Access Compliance Report

Public Rights-of-Way

(Pedestrian Signals)

Intersection ID: N/A	Main Street:	Cross Street: N/A	Location: N/A
ADA ID: DA5AA1E49156	Signal Type: Two Push Buttons-Non APS	Overall Compliance: No	Severity Score: BTN 1:N/A BTN 2: N/A No BTN: N/A
Codes/Mitigation Info/Possible Solution		Field Measurements/Component Compliance

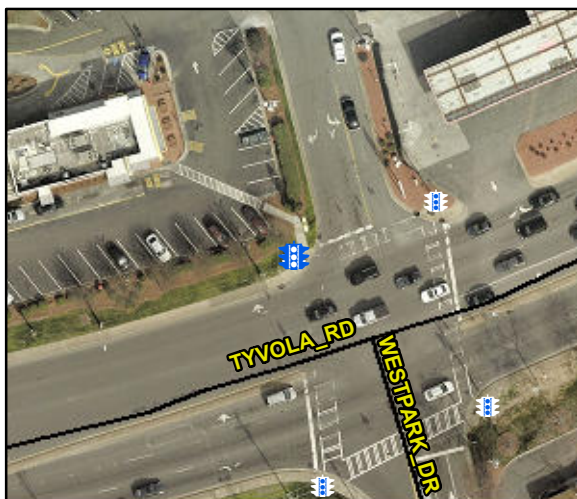
Possible Solutions: Provide PAR As Indicated. Provide Push Button Extension. Remove and Replace Clear Space.

PROW/ADA: R404.3, R404.2, R406.2
